U.S. NUCLEAR REGULATORY COMMISSION
REGION IV

Inspection Report: 50-445/95-25
50-446/95-25

Facility Name: Comanche Peak Steam Electric Station, Units 1 and 2

**TURBINE DRIVEN AUXILIARY
FEEDWATER PUMP OVERSPEED
EVENTS OF JUNE, 1995**

EXISTING DRAIN SYSTEM ARRANGEMENT

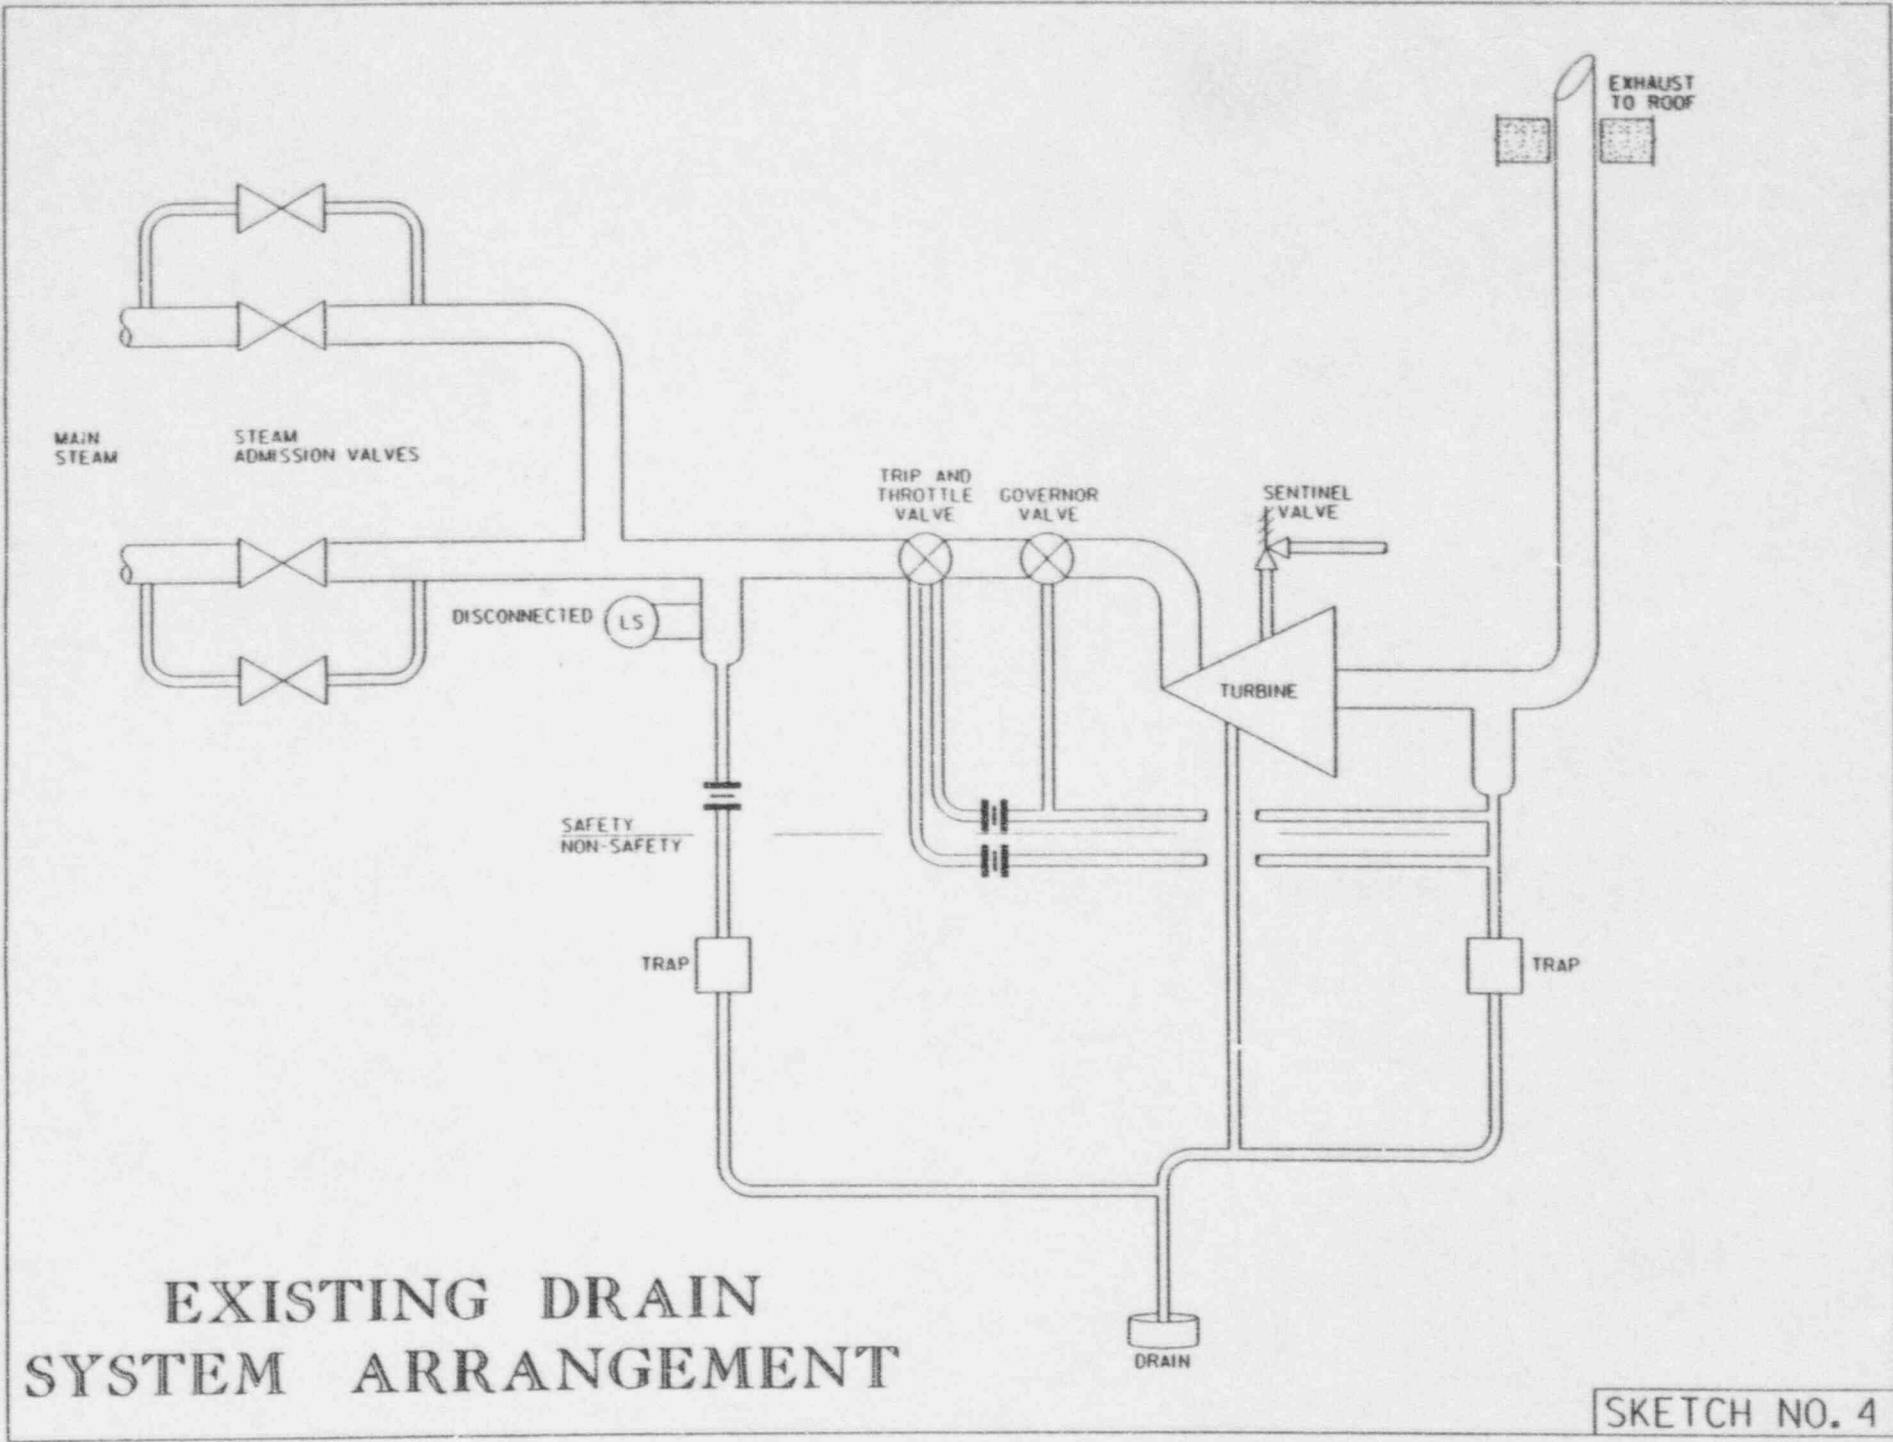
- Degraded steam trap performance reduced the drain system capability.
- Alarms for water level in the drain system are not part of the current design
- Slight binding was detected in the governor valve cam linkage
- Inboard packing bushing damage may have increased stem drag

Updated Diagram of
Planned Condensate Control
Modifications

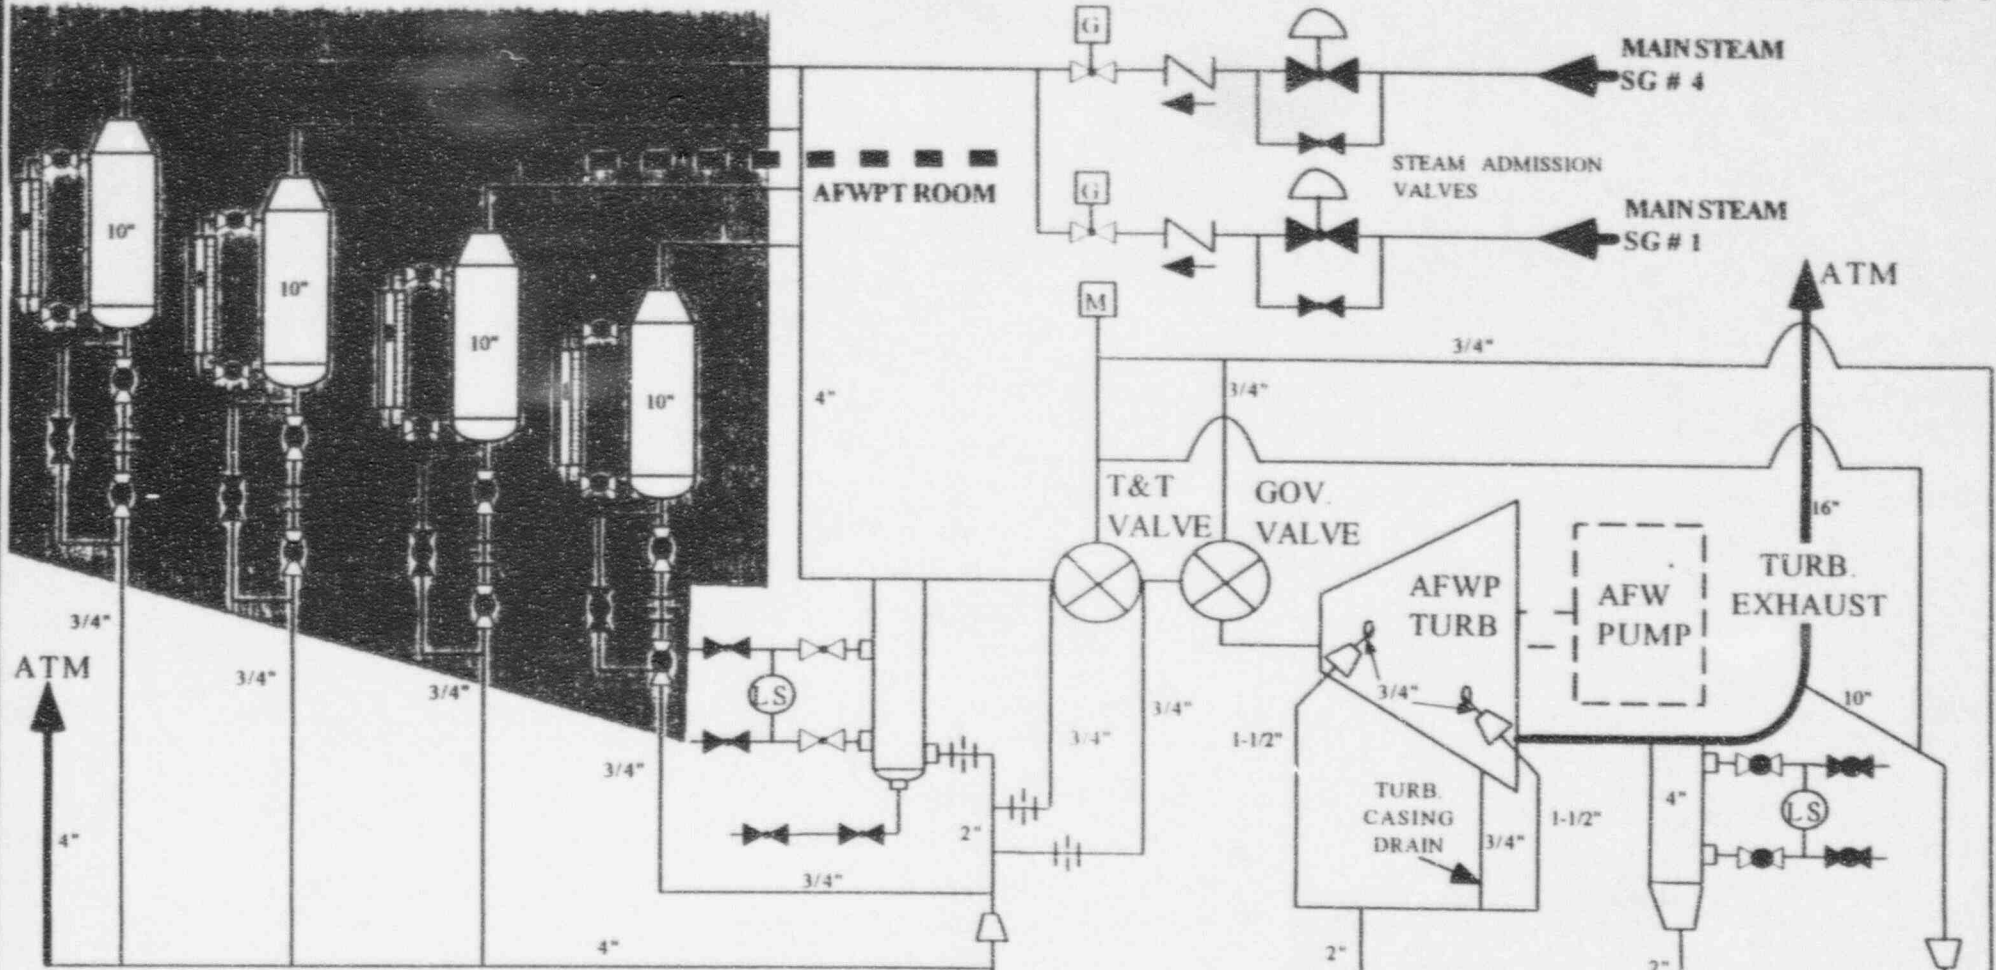
On November 22, 1995, licensee personnel provided a draft of their reliability and performance improvement initiative for the auxiliary feedwater pump turbines (see Attachment 4 to this report). They planned to use a single 4-inch line to provide steam to the turbine. By making the interconnection near the steam admission valve, they would eliminate half of the cold piping and, therefore, half of the condensate formation. They planned to install condensate knock out pots to dynamically remove condensate during cold starts. They also planned to evaluate either: (1) revising the opening characteristics of the steam admission valves or (2) adding startup bypass valves to admit steam to the turbine in a more controlled manner. They also planned to replace the steam traps with a flash tank to improve steamline drain reliability. The inspector concluded that licensee personnel aggressively developed corrective actions to prevent turbine-driven auxiliary feedwater overspeed trips due to condensate accumulation.
